ERRATA

TO THE TSB12C01A 1394 LINK LAYER CONTROLLER DATA MANUAL

(TEXAS INSTRUMENTS LITERATURE NO. SLLS219A, FEBRUARY 1997)

TSB12C01A Document Changes

Figure 4–Y. Receive Self-ID Format

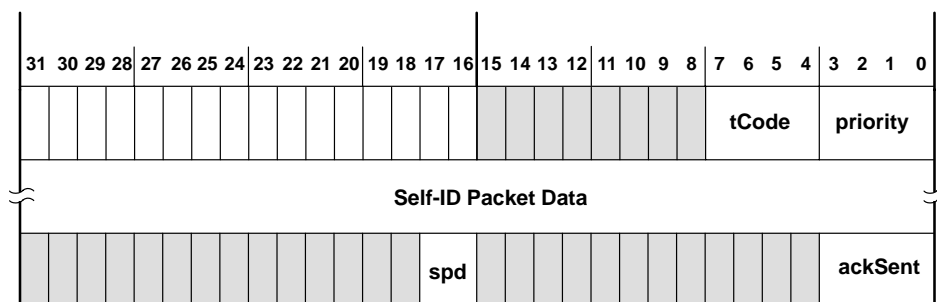
- aa. Make the following change to Figure 2–2, *TSB12C01 Terminal Functions* on page 2–5 of the first revision of the TSB12C01A data manual (TI literature number SLLS219) **ONLY**:
- Change CYDNE to CYDNE by removing the overbar from the CYDNE signal name. The signal CYDNE is an active-HIGH signal and should not be shown with an overbar.
- Revision A of the document, SLLS219A, is correct, both standalone and as part of the *IEEE 1394 Circuits Data Book*, 1997, TI literature number SLLD004.
- bb. Replace the *Receive Self-ID* paragraph, figure, and table where indicated in the specified documents, with the following paragraph, figure, and table.

The format of the receive Self-ID packet is shown in Figure 4–Y. The first quadlet is the packet header with the special tCode of Eh. The quadlets that follow are a concatenation of all the received Self-ID packets, followed by the final packet status quadlet.

FIELD NAME	DESCRIPTION
tCode	This field carries the special transaction code of 1110b.
priority	This field carries the priority level for this packet.
Self-ID packet data	This field contains a concatenation of all the Self-ID packets received.
spd	This field indicates the speed at which this packet was sent. All Self-ID packets are sent at the base rate of 100 Mbps. spd = 00 for 100 Mbps
ackSent	This field holds the acknowledge sent by the receiver for this packet.

Where Paragraph 4–X, Figure 4–Y, and Table 4–Z are:

TSB12C01A Data Manual, TI Literature Number SLLS219, September 1995, page 4–8:
Paragraph 4–7 Receive Self-ID, Figure 4–10, and Table 4–10

TSB12C01A Data Manual, Revision A, TI Literature Number SLLS219A, February 1997, page 4–9:
Paragraph 4–8 Receive Self-ID, Figure 4–11, and Table 4–11

IEEE 1394 Circuits Data Book, 1997, TI Literature Number SLLD004, June 1997,
TSB12C01A Data Manual, Revision A, February 1997, data book page 2–41:
Paragraph 4–8 Receive Self-ID, Figure 4–11, and Table 4–11
